Brooklyn Inland Wetlands Commission
Regular Meeting Agenda
Tuesday, October 10, 2023
Zoom and In-Person Meeting
Clifford B. Green Memorial Center
69 South Main Street
6:00 p.m.

1. IWWC 23-010 A. Kausch & Sons, Church Street, Map 37, Lot 21, RA Zone; Driveway with wetlands crossing; 2,100 sq ft of wetlands alterations for single-family house, septic system, well and grading in the upland review area.

ENGINEER'S REPORT SITE DEVELOPMENT PLAN REVIEW CHURCH STREET & POMFRET LANDING (MAP 37, LOT No. 21) BROOKLYN, CT (September 25, 2023)

Site Development Plan

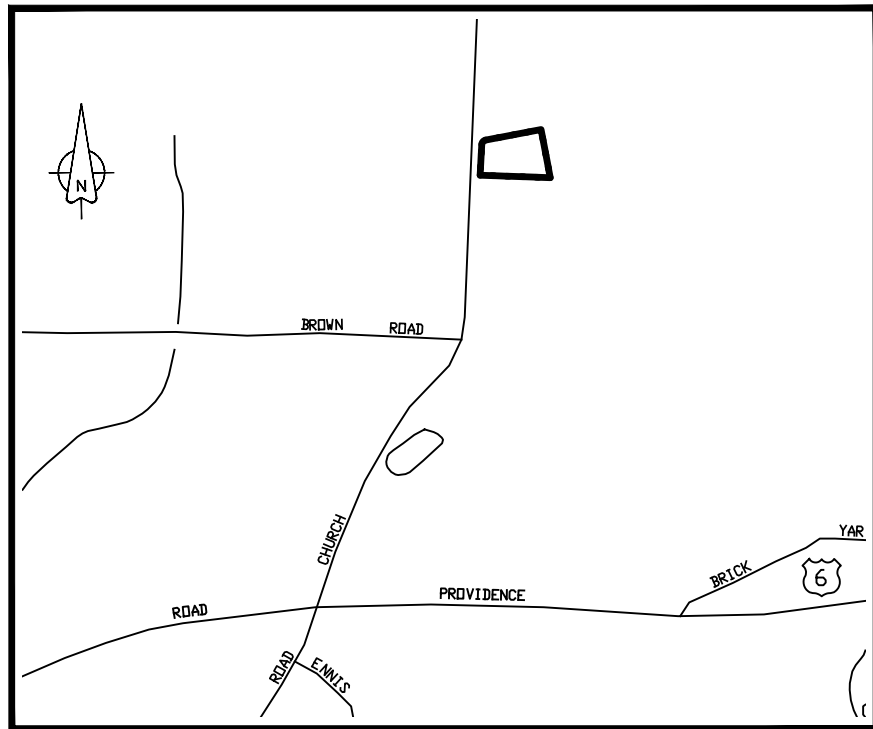
1. The professional engineer's and land surveyor's seals are missing from the plan.
2. Proposed grading around the proposed house needs to be added to the plan. This needs to demonstrate that overland stormwater runoff can be diverted around the dwelling and attached garage.

3. The finish elevation of the building slab is not indicated on the plan.
4. A "deck" with stairs is shown to the rear of the house; however, it is unclear how this will be constructed.

5. Rip rap splash pads need to be shown on the plan at the inlet and outlet of each pipe.
6. Actual field derived spot elevations are needed in close proximity to both ends of the proposed pipe installation and where rip rap will be installed since it is noted on the plan that contour elevations on the plan are "approximate." Spot elevations will serve as an aid in evaluating the invert elevations stipulated on the plan versus actual field conditions.

7. Drainage calculations are needed to verify the size of the proposed pipes in the driveway. This requirement is to evaluate the safe handling capacity of the culverts of runoff from the entire watershed contributing to flow through the pipes.

10. The area of wetland disturbance (2,100± sq. ft.) for driveway construction needs to be identified on the plan using a cross-hatched symbol.
11. Test Pit #1 identification has been masked by the proposed septic system leach field and needs to be relocated on the drawing to clearly identify the test pit number.

12. According to Test Pit #2 & #3 data represented on Sheet 2 of 2, it appears that the slab of the proposed house will be very close to the average seasonal high water table indicated by mottles at 20" and 26", respectively. I have seen conditions like this in the past causing a concrete slab in a house to crack (fail) and become displaced. *I strongly recommend the professional engineer review this more closely and develop a method of protecting the slab from potential failure due to the close proximity of high seasonal groundwater levels.* This may require filling a portion of the site where the house with garage will be located.

13. According to data presented for Test Pit #2 on Sheet 2 of 2, the "reserve septic leach field" is not in a location as good as that of the primary leach field system. Has this been carefully evaluated by the Northeast Connecticut District Department of Health?

14. It is important to note that the Test Pit and Percolation Test locations drawn on the plan do not correlate at all to the NDDH Sanitarians field sketch. Why the discrepancy and how may this affect the location of the septic system primary and reserve leach fields?

15. According to the existing and proposed contour elevations on the plan it appears that the septic system may need to include a pump in order to operate. Is a pump required and if so, the pump chamber needs to be included on the plan? Lack of septic system elevations on the plan makes it difficult to ascertain this.

16. The "Building Setback Line" symbol in the "Legend" does not appear on the Site Plan.
17. Symbols in the "Legend" not used in the Site Plan need to be deleted from the plan to avoid confusion.

Plan modifications based upon the comments above need to be resubmitted for further review.

Site Development Plan
"Detail Sheet"

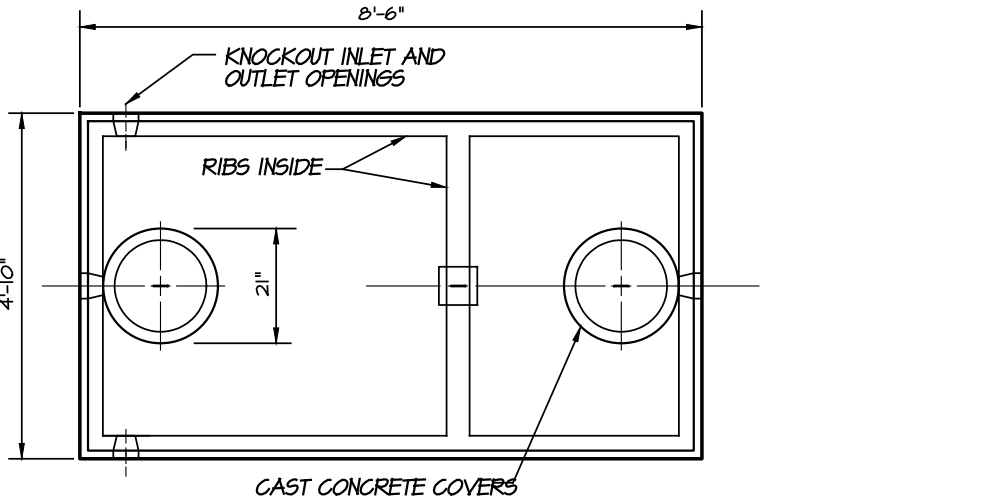
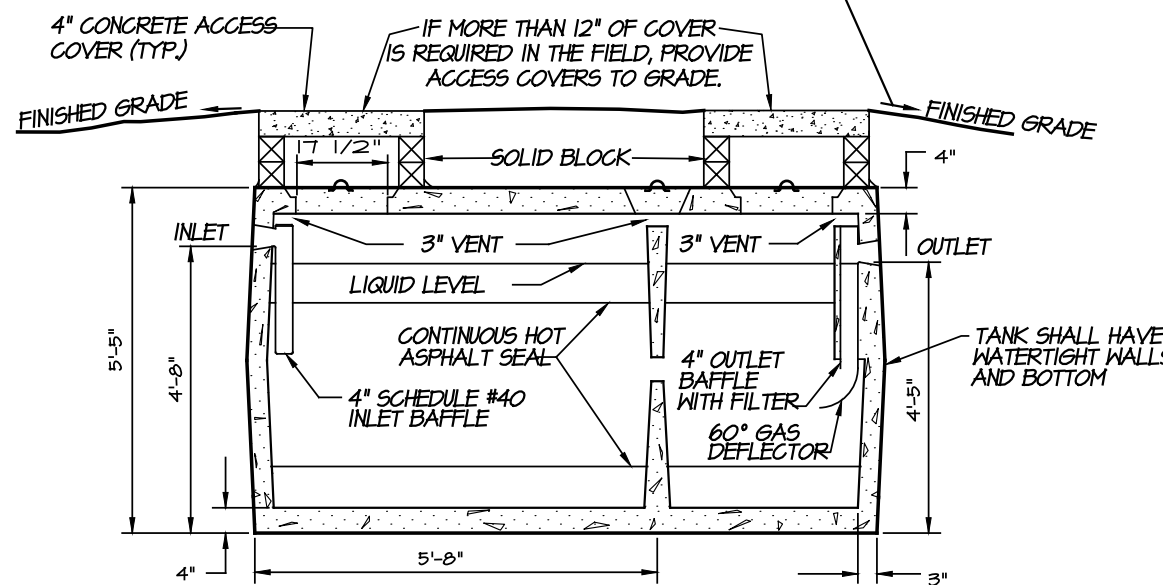
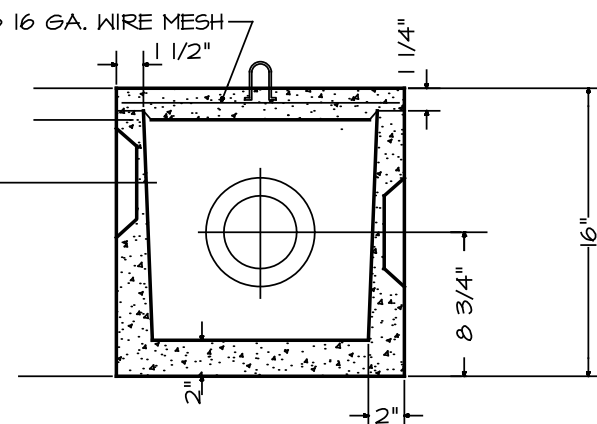
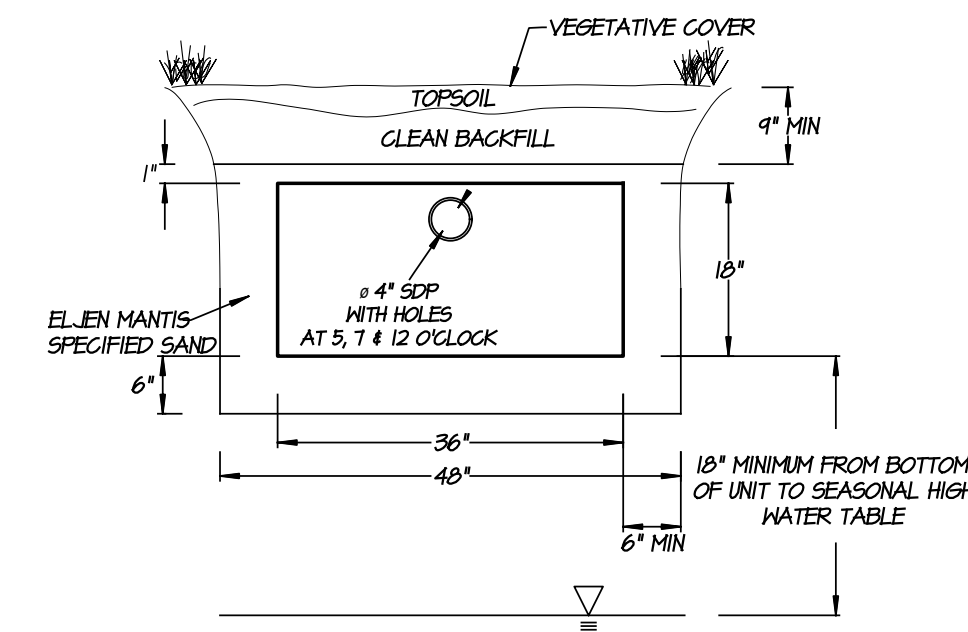
1. The professional engineer's seal and signature is required on this plan.
2. A driveway typical section detail needs to be added to this plan.
3. A detail of the rip rap splash pads need to be added to this plan.

4. Lawn seed varieties with percentage of each need to be stipulated on the plan and not rely on a contractor looking through the Connecticut 2002 Guideline for Erosion and Sediment Control, assuming they don't have a copy of that.

5. Pipe invert elevations need to be added to the upper "Wetland Crossing" cross-section and the slope of the pipe corrected to indicate the difference between the inlet (elevation 283.75) and outlet (elevation 283.40) as well as the length of the pipe to be installed. Also, elevations need to be added to the ends of horizontal delineation lines, distances indicated at the bottom of the vertical column delineation lines, and the title of the detail needs to include the words "Cross Section." Furthermore, there is a note here stating "*remove exiting topsoil/organics and provide bedding & backfill material per detail.*" Where is the detail and what is the specification of the backfill material?

6. Elevations need to be added to horizontal lines in the lower "Wetland Crossing" profile detail and spot elevations added over each 15" pipe. Distances in feet need to be indicated at the bottom of vertical lines. Also, the title of the detail needs to include the word "Profile." Furthermore, the note "proposed grade" is meaningless as there are no elevations, spot or otherwise, defining the "proposed grade." This needs clarification.

7. Note 3 under "Septic System Construction Notes" needs correcting to agree with the Septic Tank detail on this sheet and the septic tank note on Sheet 1 of 2.

8. Strength classifications of the precast concrete components of the septic system need to be noted on the plan, e.g., H20.
9. The "continuous hot asphalt seal" in the Cross Section of the "1,000 Gallon 2 Compartment Septic Tank" detail does not belong in this detail and needs to be removed. Furthermore, this detail appears to be for a 1,250 gallon tank, not a 1,000 gallon tank. The detail needs to be adjusted, accordingly.

10. The "Typical Leaching Trench Section" does not appear to be drawn according to the NDDH sanitarians comments in his Subsurface Site Investigation report of June 22, 2023 wherein it is stated that "*The bottom of the system must stay 4" above grade*" and that the "*MLSS must be addressed on the engineered plan.*" The detail needs to be revised to reflect this.

11. The "Standard D-Box" detail is incomplete as it is missing an elevation view along the longitudinal axis and a plan view.
12. If a pump chamber is needed for this system, a detail of this needs to be added to this sheet.

13. If this plan is to serve as an "engineered plan" for the construction of the septic system, much information to do that is missing, i.e., elevations, distances, etc.
